FREDERICK COUNTY PLANNING COMMISSION

TITLE: Chick-fil-A Riverview Plaza

FILE NUMBER: SP-95-23, AP#15330, APFO#15332, FRO#15333

STAFF REPORT

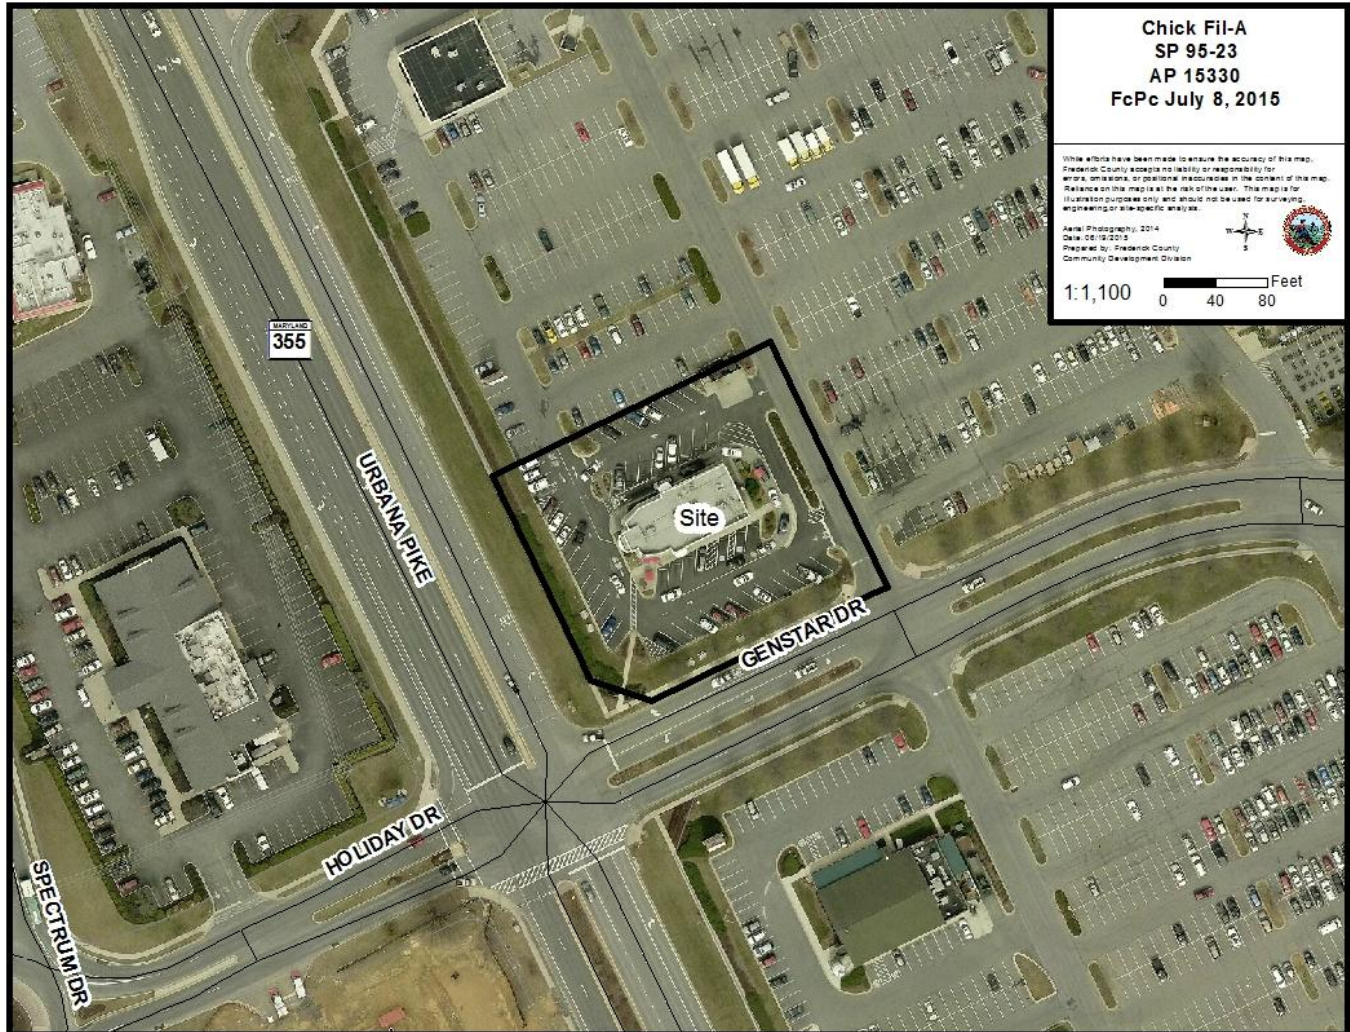
1. Parking Modification (§1-19-6.220.A.1) to allow 71 parking spaces rather than the required number of 24.
2. Loading Modification (§1-19-6.210.A.2) to allow one large loading space, with a modified dimension of 16'x66', in lieu of the required 12'x50' loading space.
3. Alternate Landscaping Plan (§1-19-6.500.I) to allow a portion of the required parking area shrubs to be located throughout the development as depicted on the Chick-Fil-A Site Development Plan rather than within the landscape area of the central parking bays
4. Lighting Modification (§1-19-6.500.B.2) to allow a light pole height of 27' rather than the maximum of 18' for commercial uses.
5. Lighting Modification (§1-19-6.500.D) to allow light spillage over the property line above the required 0.5 foot candle limit.

Phasing and Construction Process: Staff and the Applicant worked together to develop a phased construction schedule in order to keep the existing restaurant's drive-through functional throughout the majority of the proposed construction, as requested by the Applicant. The Phasing plan will allow the drive-through portion of the restaurant to remain open for approximately 14 of the 21 weeks of estimated construction time. The Phasing plan details the installation of temporary fencing, designed to separate the drive-through patrons and restaurant employees from any construction activity on site. The site is anticipated to be fully closed during the last 7 weeks of construction represented as Phase III. Staff requested that the Applicant provide copies of the Phasing Plan as part of the site development plan submission package for information purposes.

Graphic #2: Site Zoning

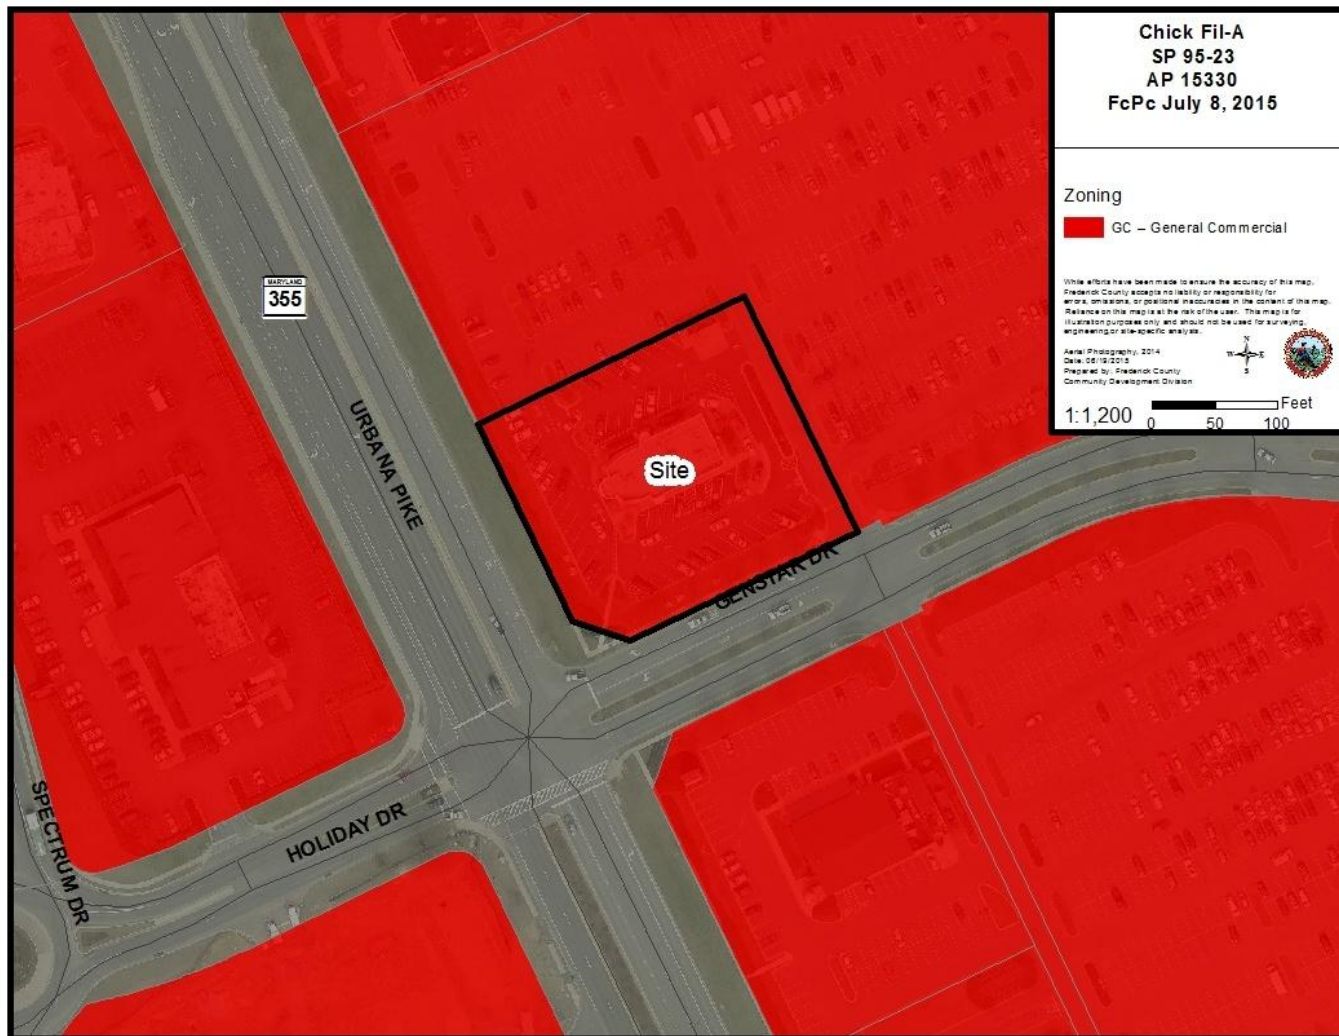
The site is currently zoned General Commercial (GC) (see Graphic #2 below). The properties to the north, south, east, and west of the site are also zoned GC. Properties to the north, south and east are developed with the existing Riverview Plaza Shopping Center. Home Depot is located on the parcel immediately to the east of the existing Chik-fil-A, with TJ Maxx, Michaels, and Staples to the north and east beyond an intervening vehicle drive aisle. CarMax is located immediately north of, and adjacent to, the shopping center northern boundary. MD 355 makes up the western property border.

Dimensional Requirements/Bulk Standards §1-19-6.100: The proposed Site Development Plan adheres to the lot dimensions required for the General Commercial Zoning District (see Graphic #2).
